CHANGES REQUESTED FOR CP43

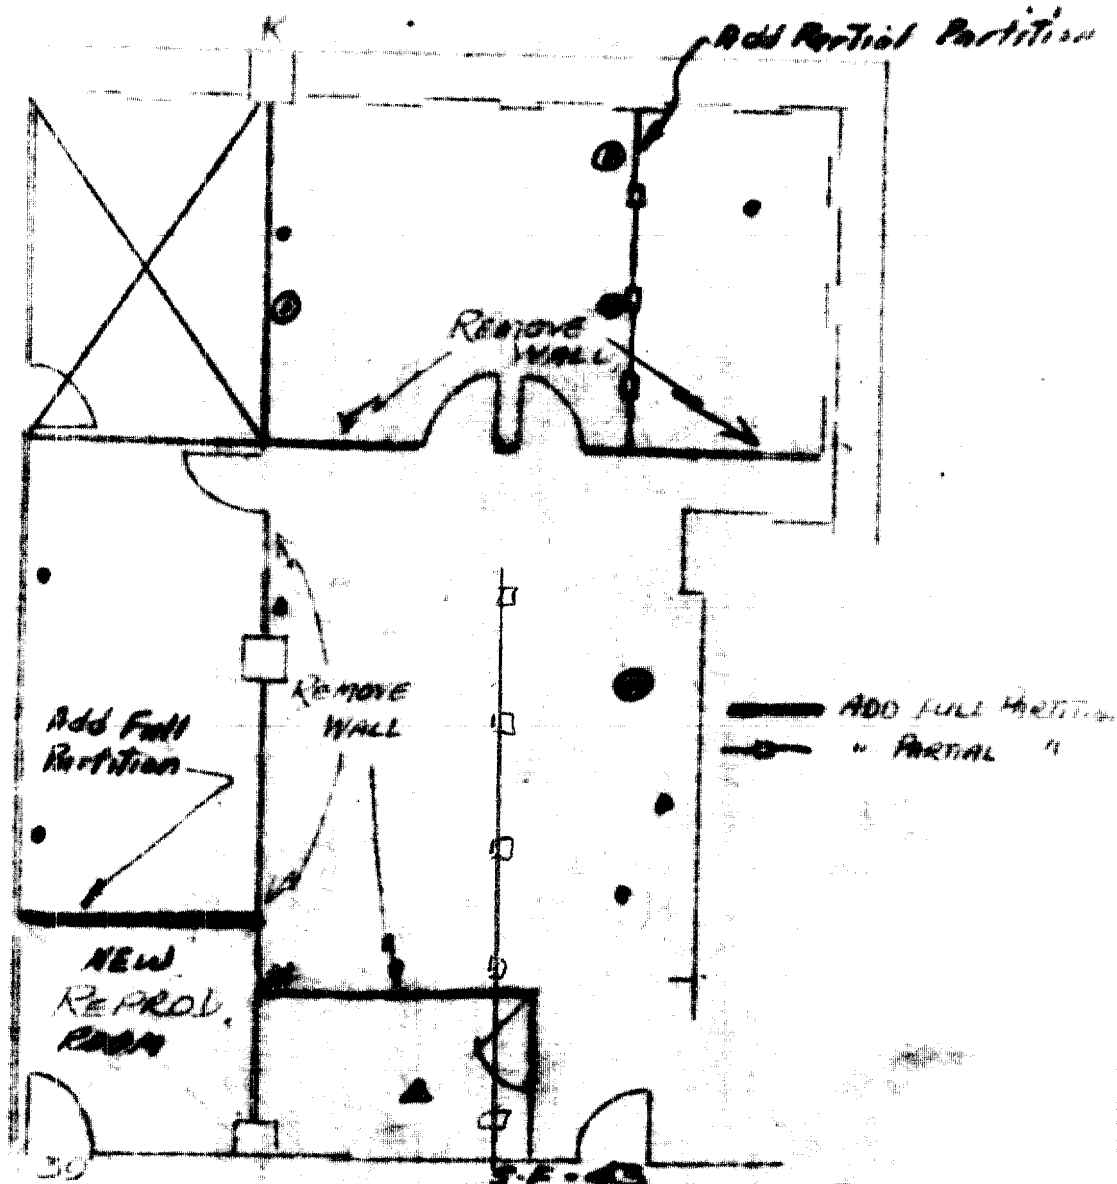
- PHONE OUTLETS TO BE CAPPED
- EXISTING PHONE OUTLET TO BE RETAINED
- ① REQUESTED NEW INSTALLATION
- ② SUGGEST TO REMOVE FOR FUTURE NEED
